Product/Process Change Notice (PCN)

PCN Number: PCN_UtLAN_20250125

Affected Series: WE-LAN

Affected Part Number: 7490140117C

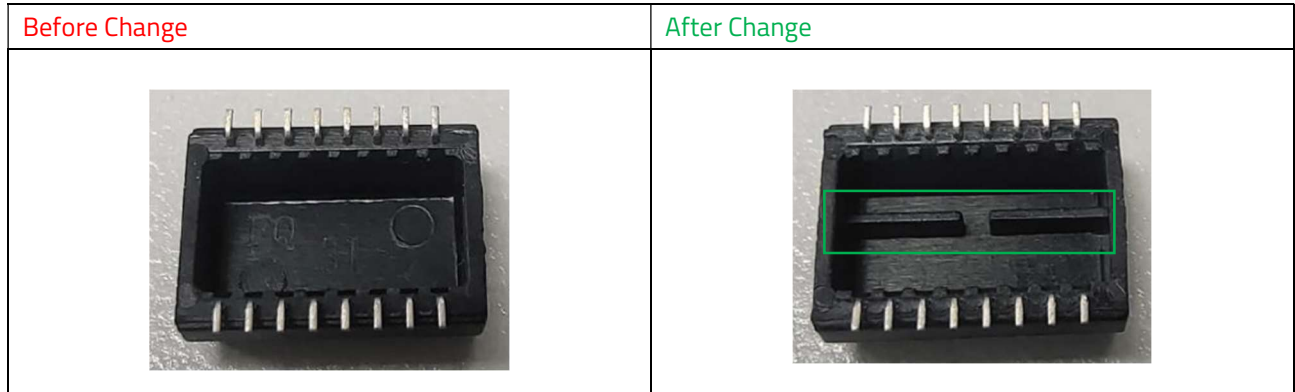
To improve the processability, Würth Elektronik eiSos will change the inside design of the housing.
 There will be no change in form, fit, function, quality or reliability of the product.
 The new revision of the affected order codes will be sent out after the previous revision is out of stock (according to FIFO - first-in, first-out).

Add plastic wall inside of the housing.
